# Proposal for SAS 2.x Specification to Enable Support for Active Cables

Gourgen Oganessyan

QUELLAN

March 7, 2008

**Figure 98 — Mini SAS 4x cable plug connector that attaches to an enclosure universal port**

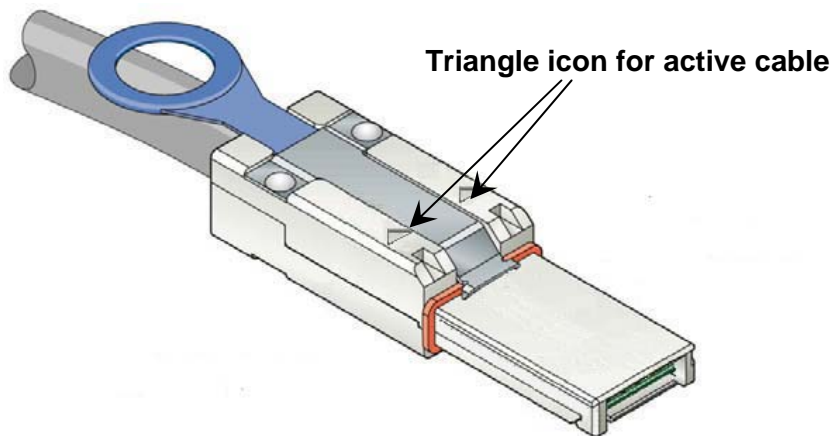
In order to ensure that active cables cannot be plugged into legacy (passive) ports, differentiating keying shall be provided by removing all the key slots from the plug connector and all the keys on the receptacle connector. In addition, two triangle icons on each side on the plug connector will be added to the plug connector to distinguish an active cable assembly (Figure 98).

Figure 98 shows an active mini SAS 4x cable plug connector that attaches to an enclosure universal port:
